Notice of Allowability	Application No.	Applicant(s)	
	10/815,520	ELLAMS PHILIP	
	Examiner	Art Unit	
	Haissa Philogene	2828

EXAMINER'S AMENDMENT

Fig. 2 IR/OR ART

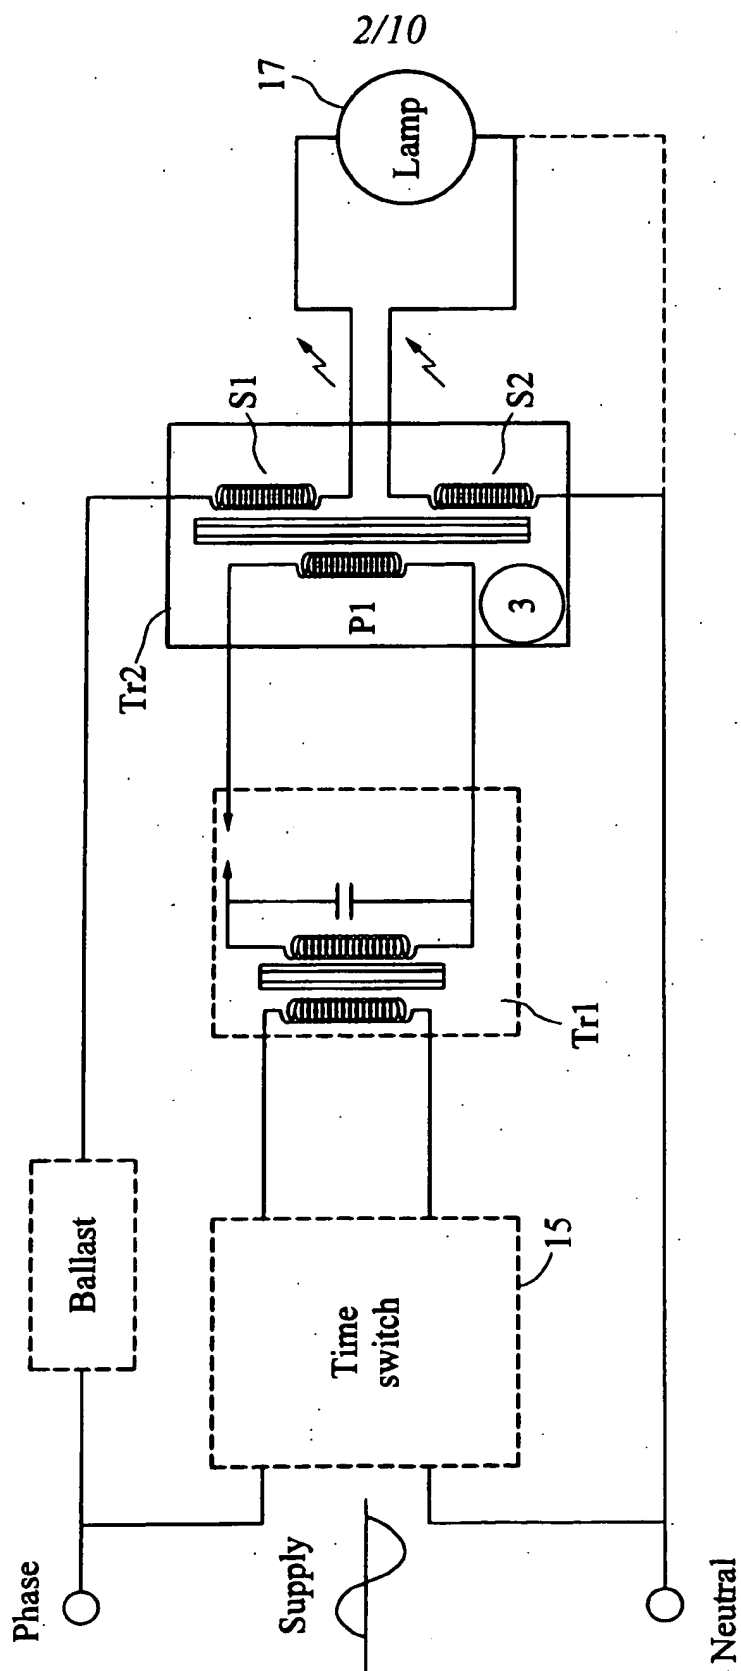
-Figures 1 and 2 have been labeled as --PRIOR ART--.
